Victoria Intimate Limited

Dakkhin Vangnahati, Boiragirchala, Sreepur Gazipur

24th January 2022

Observations

Lateral load resisting system consideration in design

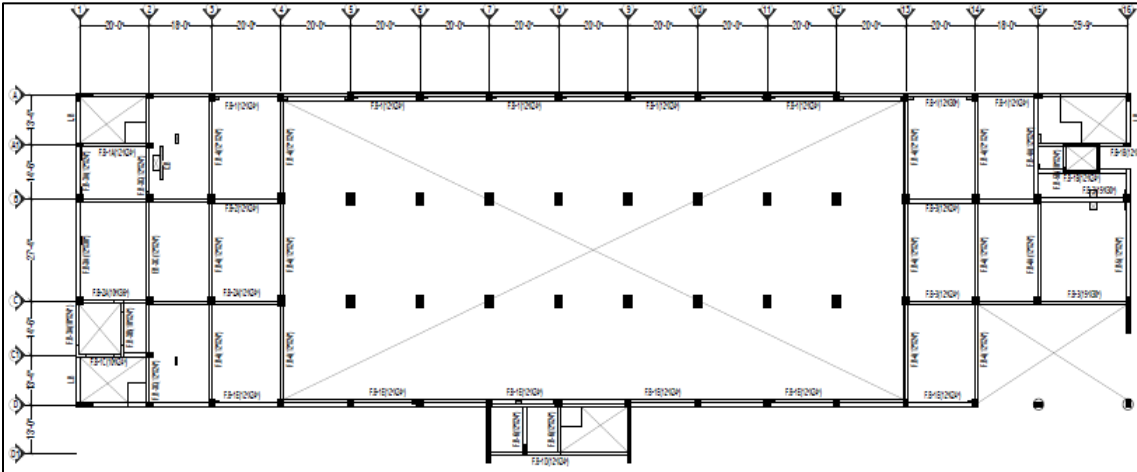
The basic structural frame system of this building is considered as DUAL system (R=9). But as per section 8.2 of the design report, the lateral load is resisted by the column only. The participation of shear walls to resist the lateral loads are not mentioned in the report. However, the building engineer is required to perform necessary checks to confirm that the DUAL framing system is functioning for this building structure.

**No design documents available for
steel mezzanine floor**

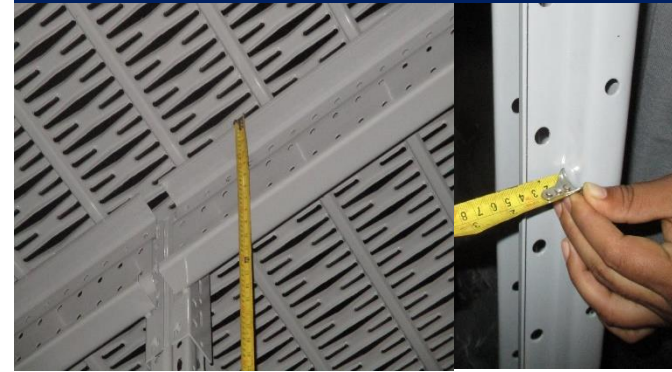
As per BNBC, every building designed shall have its design documents prepared in accordance with the provision of Section 1.9.1. The design document shall include a design report, material specifications and a set of structural drawings.

During inspection, the steel mezzanine floor was being used for storage. The structure has no foundation isolated foundation. However, the factory engineer is required to survey the structure and prepare a set of design documents in compliance of BNBC.

Lateral load resisting system consideration in design

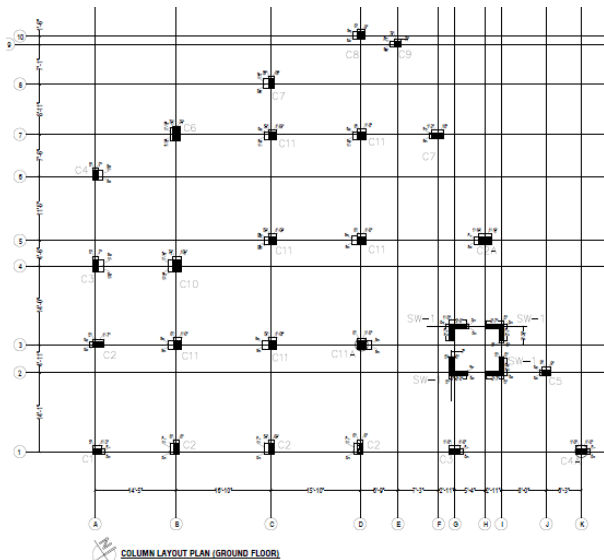
The basic structural frame system of this building is considered as DUAL system (R=9). But in the super structure of the building there is no shear wall or bracing system. However, the building engineer is required to revise the design report considering actual framing system. Also, all irregularities checks are not added in the design report which needs to be incorporated.

Column layout: No shear wall or bracing in the building

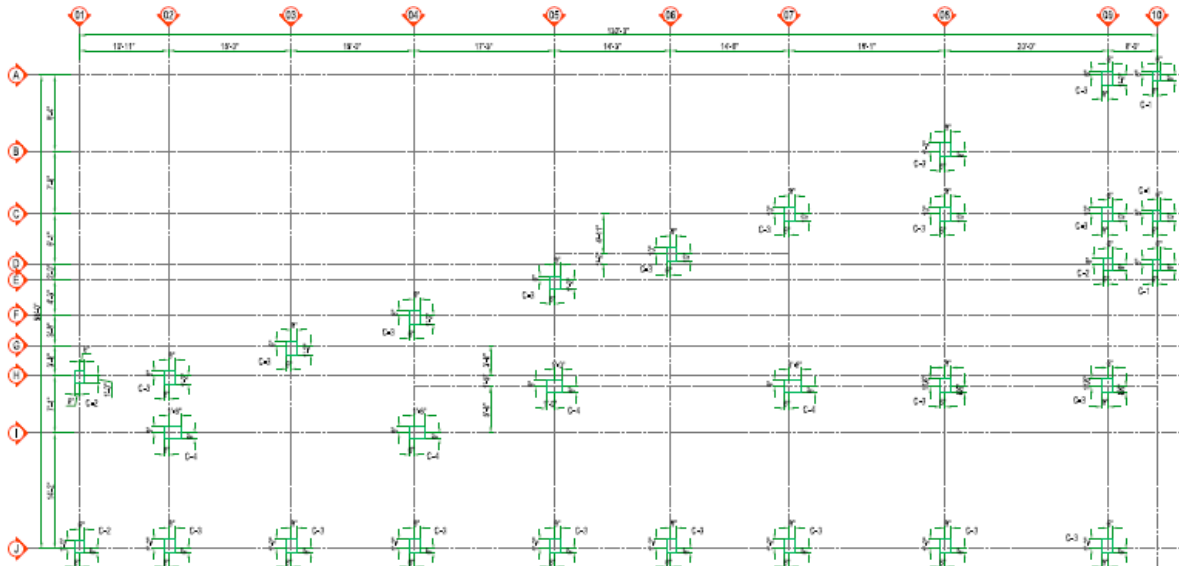
The basic structural frame system of this building is considered as DUAL system (R=9). But in the super structure of the building there is no shear wall or bracing system. However, the building engineer is required to revise the design report considering actual framing system. Also, all irregularities checks are not added in the design report which needs to be incorporated.

The long column of utility building

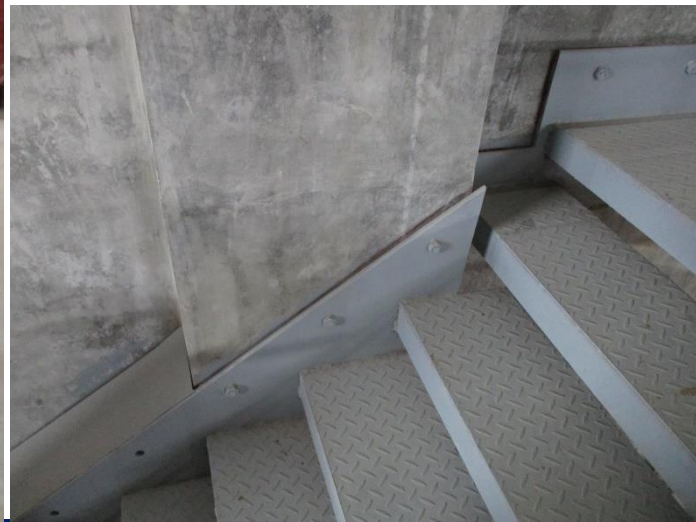
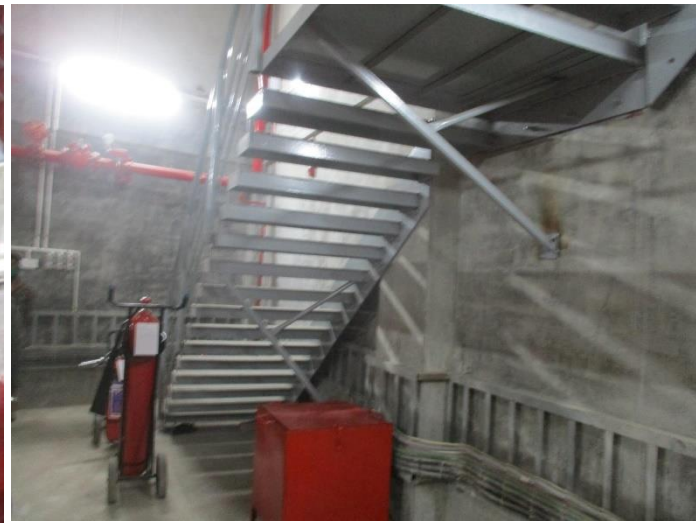
The column length is 7 m. The size of column is 375 mm x 500 mm. The building engineer to check the slenderness effect for the columns and incorporate the design in the report.

The adequacy of the steel stair for design load is apparently inadequate. Building engineer is required to check the adequacy of the stair and suggest proper remedial actions accordingly.
